PLANT NAME: St. Lucie Unit No. 1
RJL 12/6/77

Re: St. Lucie Unit 1
Docket No. 50-335
Inservice Inspection Program

Your letter of September 12, 1977 requested additional information on our proposed inservice inspection program for St. Lucie Unit 1. The information you requested is attached.

FIGURE 16. THE REACTOR PRESSURE VESSEL CLOSURE HEAD ON ITS STAND AT ST. LUCIE PLANT UNIT 1

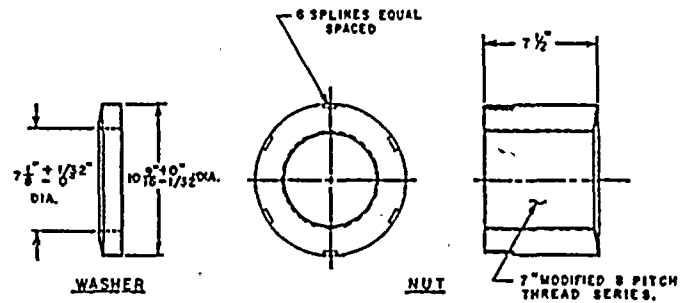
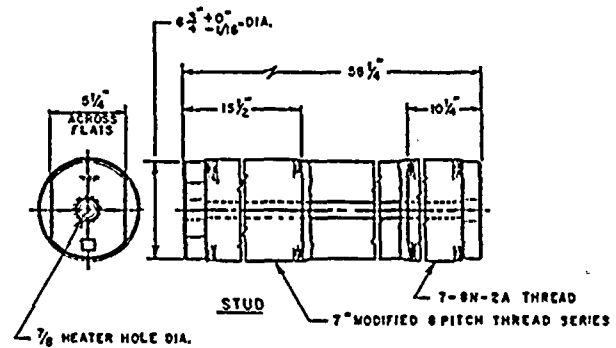
Question 1: Provide a detailed explanation of the inaccessibility of the reactor pressure vessel (RPV) closure head dome welds (item no. Bl.2) which prevent the required volumetric examination. Provide the radiation level expected at this location. Also, discuss any other forms of inservice inspection you have considered and the reasons they were considered impractical.

Answer: The RPV closure head dome weld and a portion of each of the meridional welds are not accessible from the outside surface (OD) due to the cooling plenum and the cluster of control rod drive mechanisms being in place. This can be visualized when reference is made to Volume I, Page 520, Figure 16 of the St. Lucie Plant Unit 1 Preservice Examination (PSI) Report. In addition, the configuration of the area is such that the control rod drive and instrumentation penetrations obstruct examinations from both the inside surface (ID) and the OD. (See Volume II, Appendix A, Figure A-6 of the PSI Report).

The RPV Closure Head was examined while on its stand (see Figure 16) with the cooling shroud in place and the Control Rod Drive mechanisms in place. The examinations were performed manually, and they were limited due to the inaccessibility of certain areas of interest.

FIGURE 1

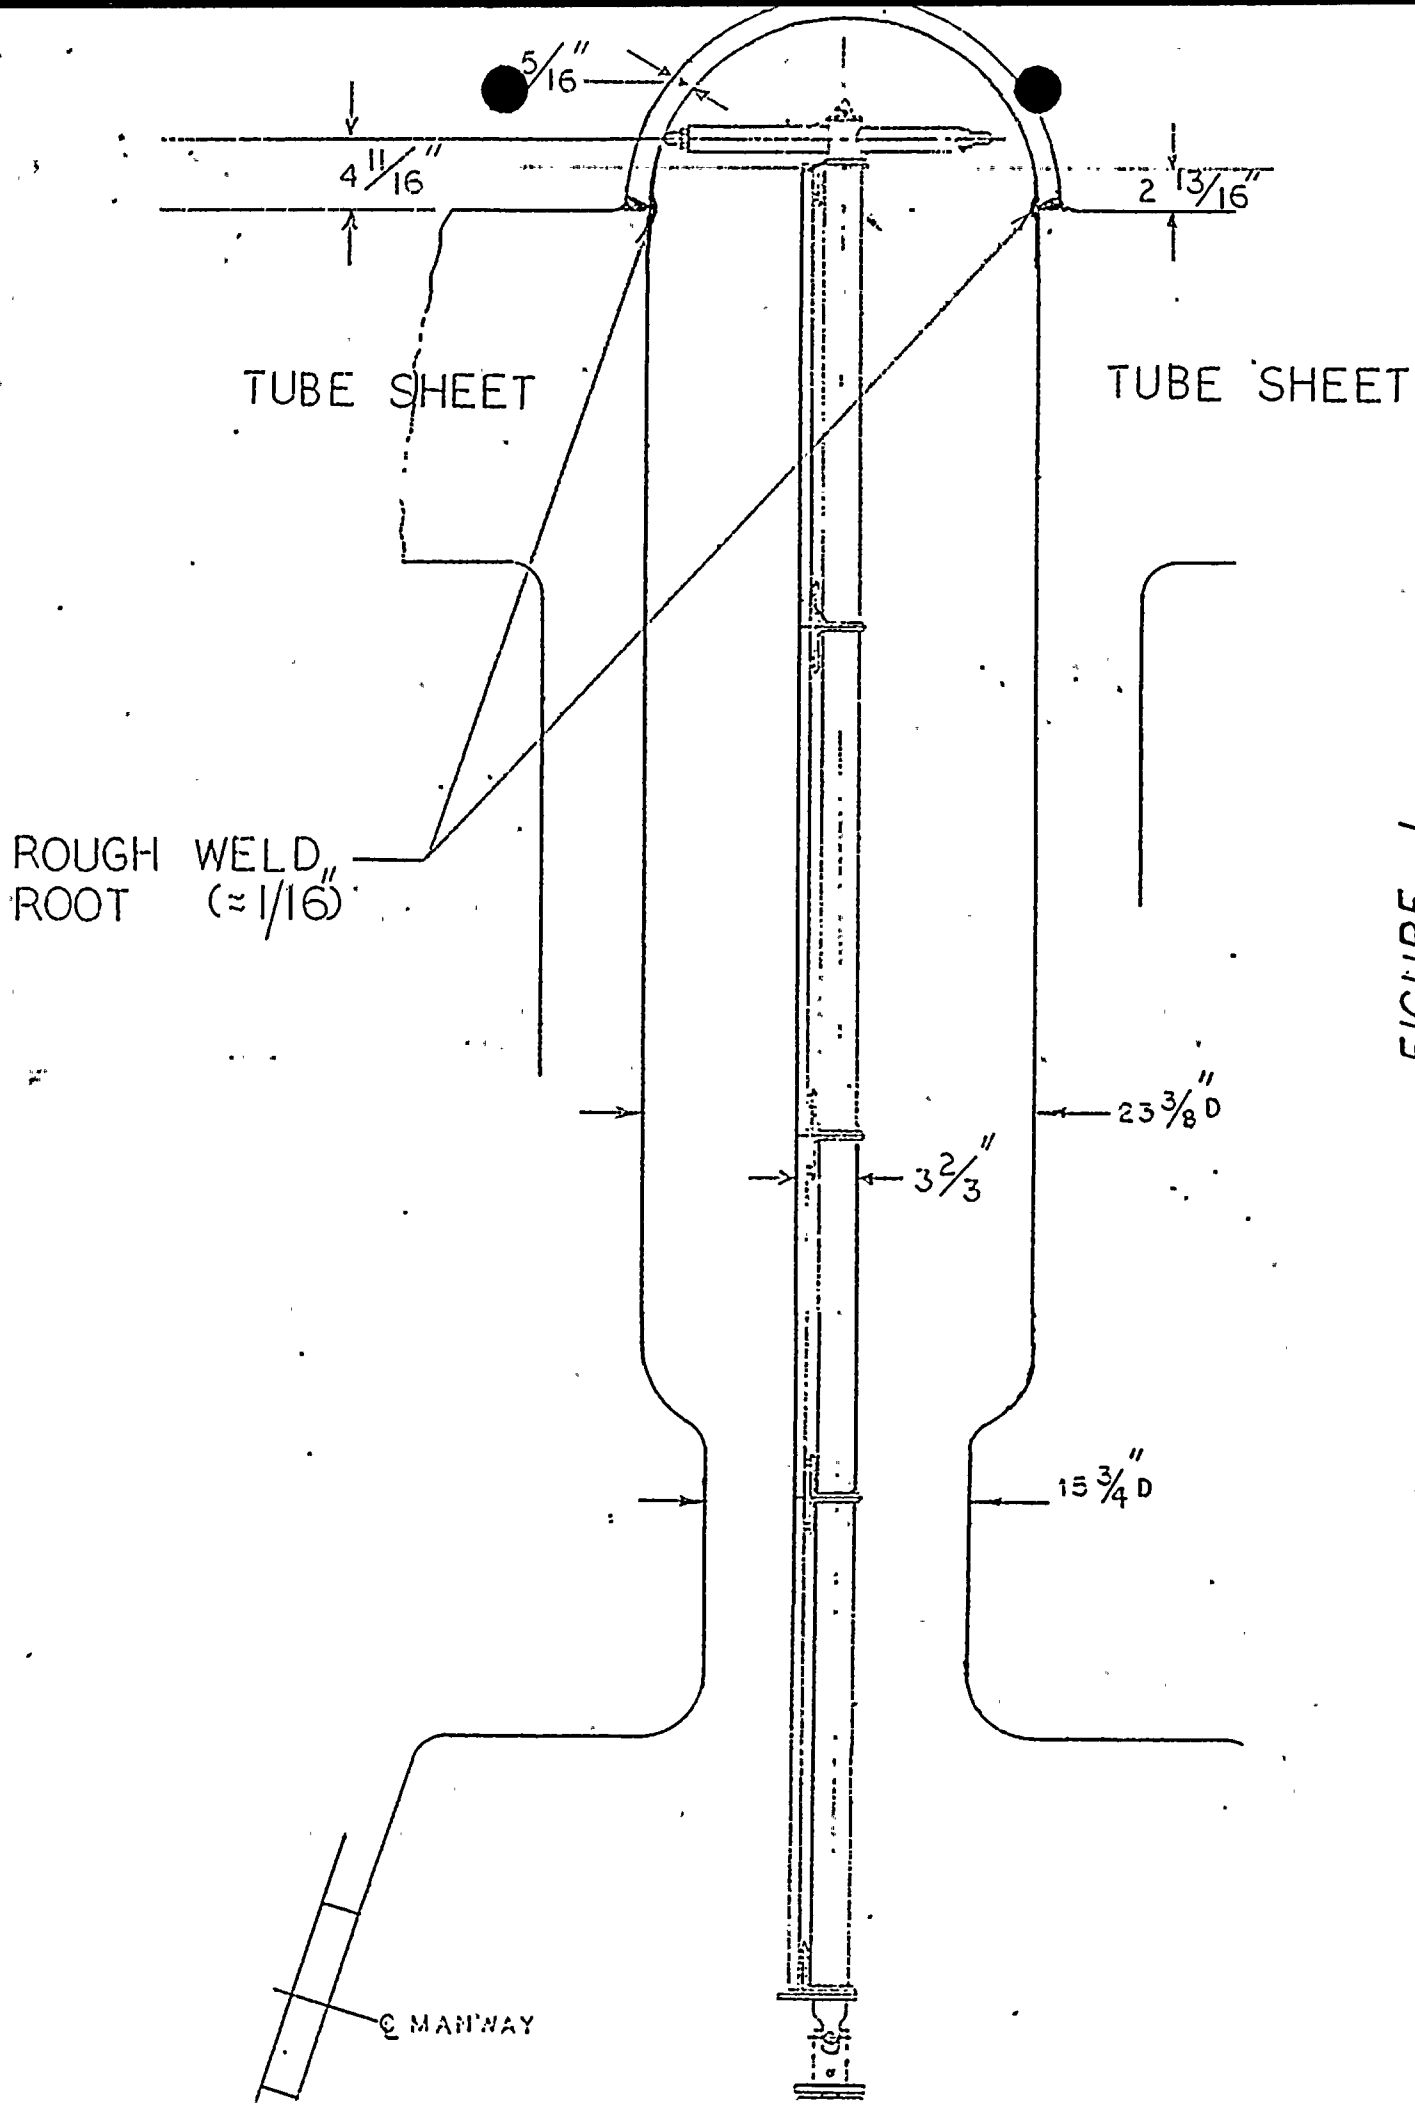
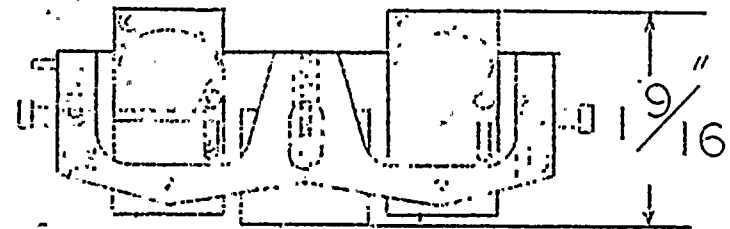
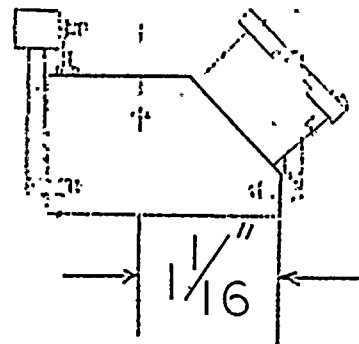
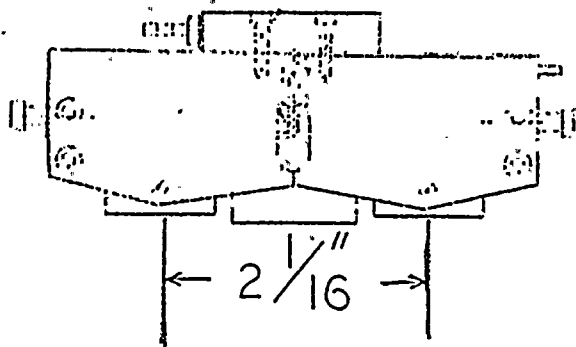
Question 7: Explain in detail why the configuration of the staywell dome-to-staywell cylinder welds in both steam generators (1A and 1B) prohibit a meaningful examination for both ultrasonic and radiographic techniques. Discuss why any alternate form of examination, such as surface examination, cannot be used in lieu of the required volumetric examination.

Answer: The staywell dome-to-staywell cylinder weld in both steam generators, due to its geometry and accessibility, is not conducive to any meaningful examination. Figure 1 shows the configuration of the staywell, the staywell dome-to-staywell cylinder weld, the permanent track installation, and specific dimensions as measured in the field during the PSI examinations. Figure 2 shows the transducer module configuration and dimensions.

As it can be seen in Figure 1, the clearance between the ultimate stop of the device is located 2-13/16 inches above the weld. The transducer module is 1-9/16 inches deep, therefore, ideally there is a clearance of 1-1/4 inch of area that can be examined. When we apply a safety factor of 1/2 inch, in order for the module to operate freely, the area scan is reduced to only 3/4 inch. But the incident point of the transducer beam is located 1-1/16 inch from the end of the shoe, so the beam in reality is not scanning the weld but only the tube sheet. This is a meaningless examination.

In the transverse configuration of the module there is the 3/4 inch area of base metal that ideally can be examined. But the root of the weld is not a smooth area and, therefore, the transducer module cannot ride over the weld smoothly. Hence, the examination is obstructed by this factor, and also by the curvature of the staywell cylinder dome.

An attempt to cover the weld from its bottom side will not be successful due to the tube sheet thickness. The beam cannot be bounced on a back wall to cover the root of the weld and again due to the area geometry only partial scanning of the weld crown and approximately the upper third of the weld can be performed. Of course, transverse examination is useless due to the tube sheet thickness and tube configurations.

Therefore, the UT examination of this weld cannot meet Code requirements and the limited examination that can be performed is not enough to produce any meaningful or conclusive results.

Radiography, surface, or visual examinations cannot be performed due to inaccessibility of the weld because of the stationary track installed for the UT examinations of the rest of the staywell cylinder welds.
